Project Title: CHUCK E. CHEESE'S

Plan Check #: 99-03337

SAN JOSE FIRE DEPARTMENT PLAN CHECK COMMENTS

Re: Plan Review: CHUCK E. CHEESE'S

3/4"=1'-0"

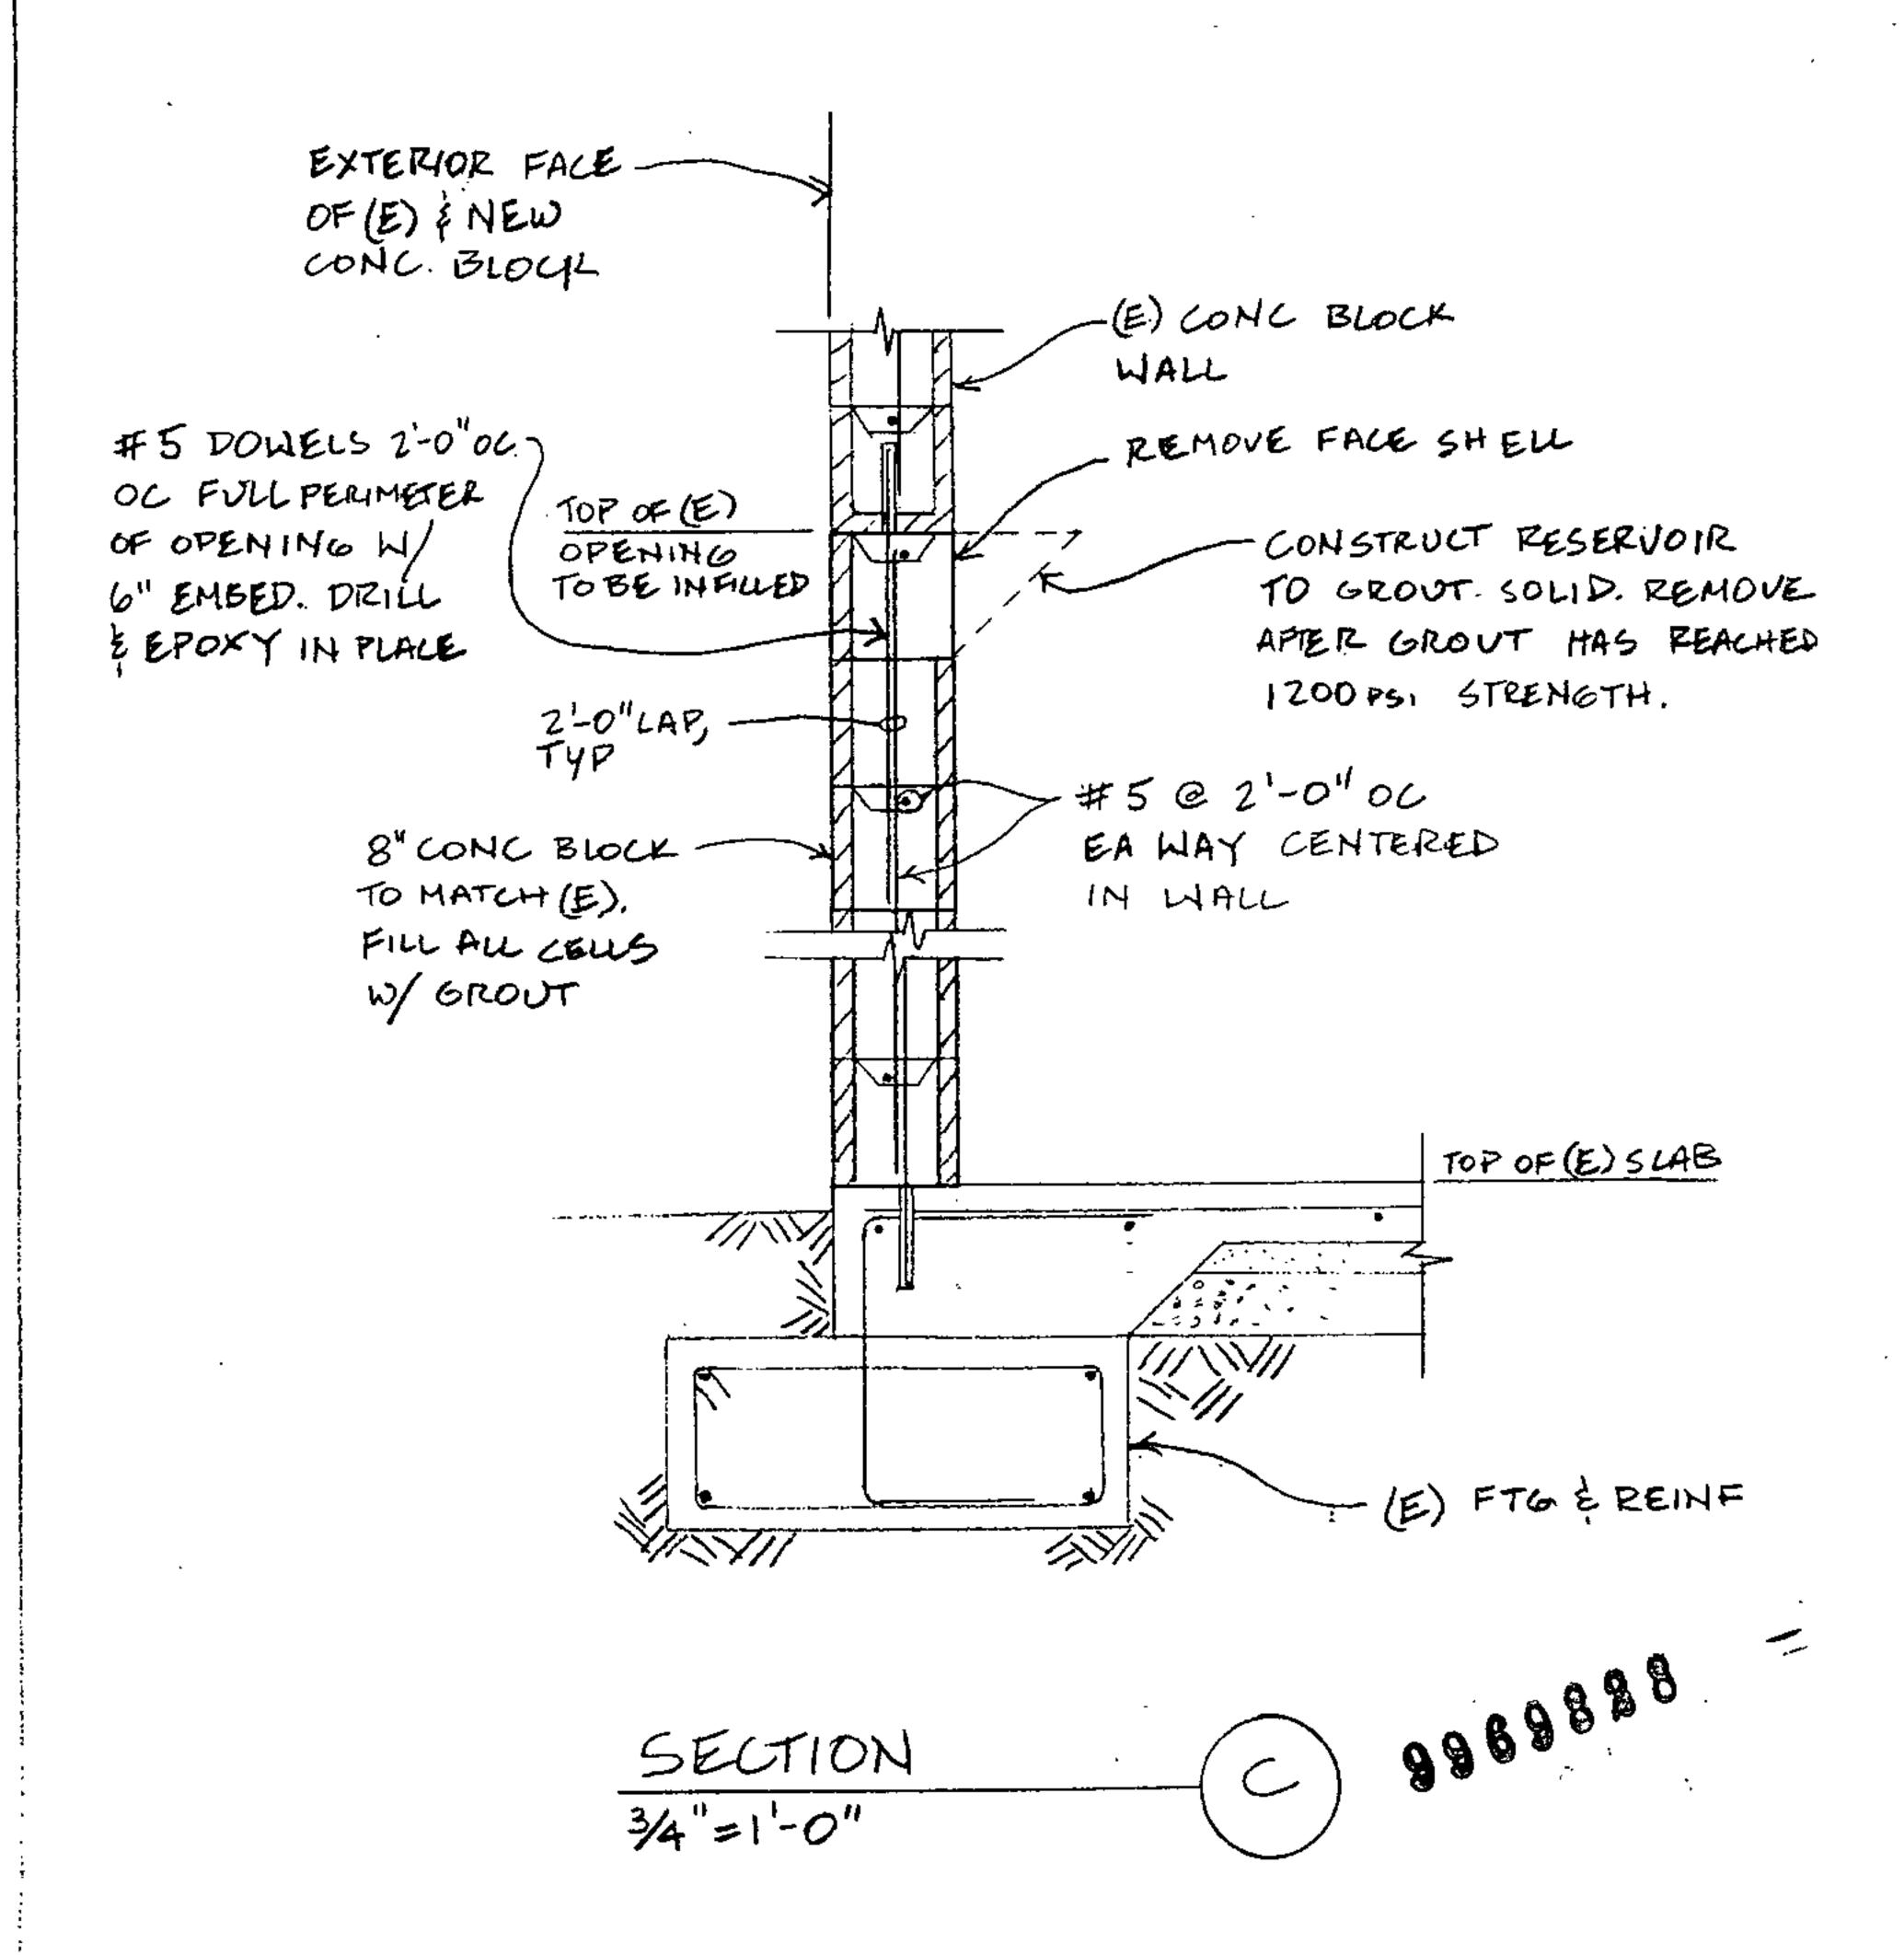
- 1. Provide details of the glass masonry to be installed at the new openings. Details of the glass block construction shall include the reinforcing and the expansion and mortar joints. Section 2110
- 2. Provide details and dimensions for the new canopy over the entry.
- 3. Provide structural details and calculations at new exterior door openings. Evaluate the capacity of the remaining shear walls. Detail all pertinent items to be field verified.
- 4. Provide structural details for fill in door openings.

- See attached detail A.
- The canopy over the entry will be a differed submittal.
- See attached detail B and Supplemental Structural calculation #1.
- See attached section C.
